# PONTIAC

## Service Craftsman News

No. 4 S-282

# STRATO-FLIGHT TRANSMISSION PARTS CHANGED

Fig. 1 First and Second Type Coupling Valves

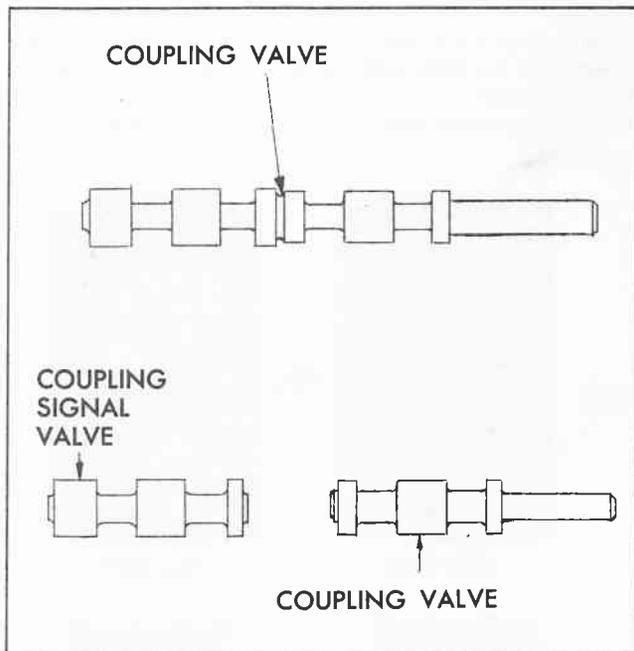
The original one piece coupling valve in the over-run clutch valve body has been replaced by two separate valves. These valves are the coupling valve and the coupling signal valve (Fig. 1). When in their operating position, the two valves have the same arrangement of lands as the original one piece valve.

The use of two separate valves improves the valve action with cold oil.

The governor boost valve has been modified and an orifice has been added in the passage which carries governor boost oil to the end of the coupling signal valve. These two changes reduce the possibility of the coupling and coupling signal valve oscillating and clicking at low speeds due to pulsations in pressure from the governor.

Fig. 2 Shift Valve Body and Spacer Identification

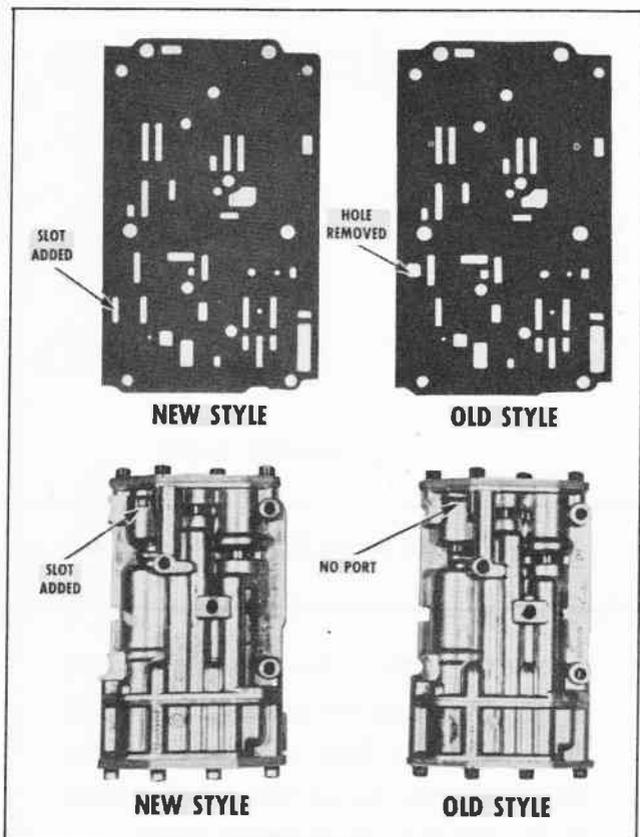
In a few very early production control valve assemblies governor boost pressure was exhausted through a hole in the spacer plate into the governor line (when the governor boost valve was closed). In later production governor boost pressure is exhausted directly to the outside through an external slot in the valve body (Fig. 2). The spacer plate used with this late type shift valve body has a slot near where the hole was located in the early plate.

When a new shift valve body is installed on an early assembly (all service parts are the late type), the spacer plate must also be replaced.

If a late type shift valve body is accidentally installed on an assembly with the early type spacer plate, governor pressure will be exhausted. As a result the transmission will not shift out of first speed.

Fig. 3 Rear Clutch Cylinder and Bushing Assembly

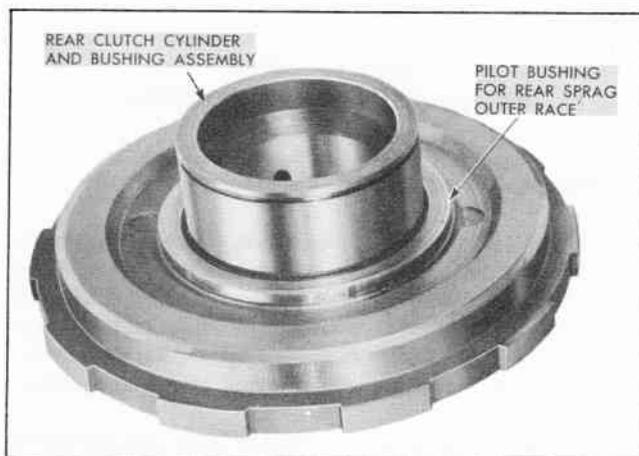
In early production the rear sprag outer race was lubrited so that it would have a suitable bearing surface where it is piloted on the rear clutch cylinder and bushing assembly.

A pilot bushing has now been added on the clutch cylinder and bushing assembly (Fig. 3). With this bushing the lubriting of the rear sprag outer race is no longer necessary and has been eliminated.

The service rear sprag outer race will continue to have a lubrited surface so that it can be used with either type clutch cylinder and bushing assembly.

Along with the new unlubrited rear sprag outer race a bronze rear sprag outer race retainer will be used. The early type retainer must not be used with the new sprag outer race and will be discontinued when present stocks are exhausted. The bronze retainer can be used with both early and late outer races.
